**NUCLEAR FUEL SERVICES, INC.**

**Subject: Supplemental Information to Support Chapter 9 and the Environmental Assessment for Renewal of SNM License 124**

## Environmental Assessment Supplemental Information

**License Renewal Supplemental Information**

**SURFACE WATER SAMPLE LOCATIONS**

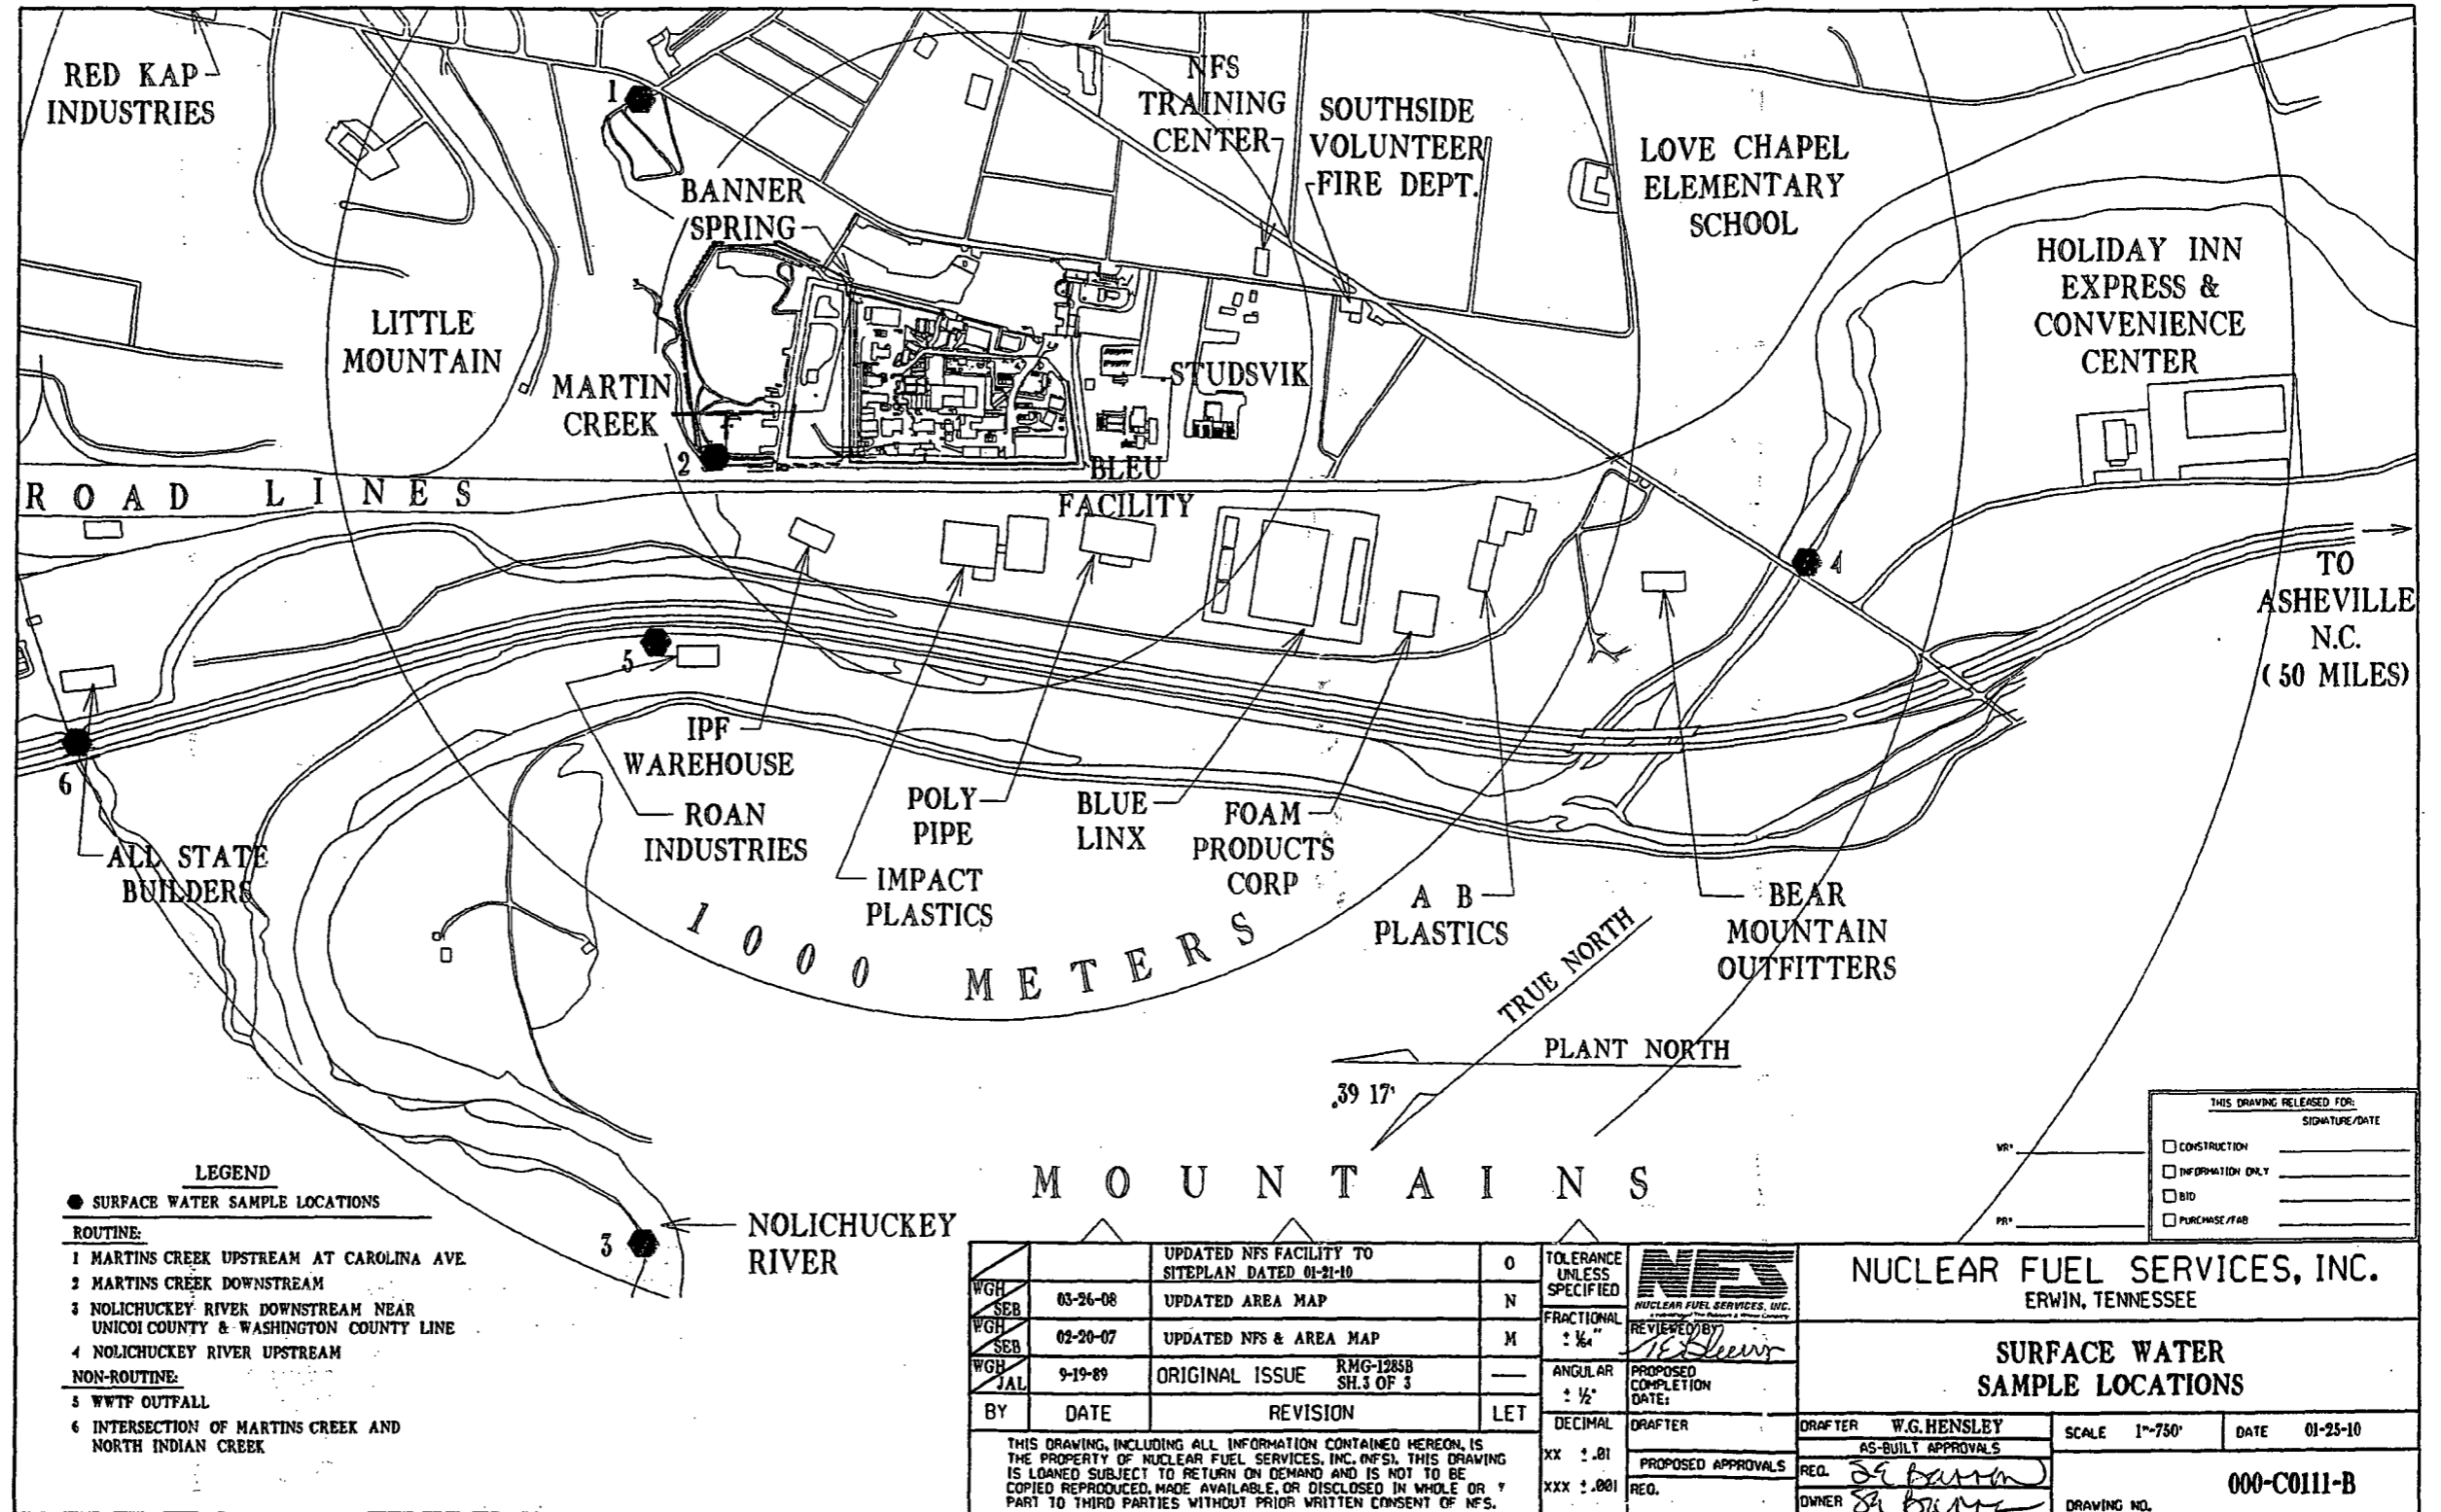
NRC asked whether NFS could provide more specific locations where upstream and downstream samples are taken. NFS stated the locations can be described in more detail.

Surface Water Sample Locations are shown on the following map.
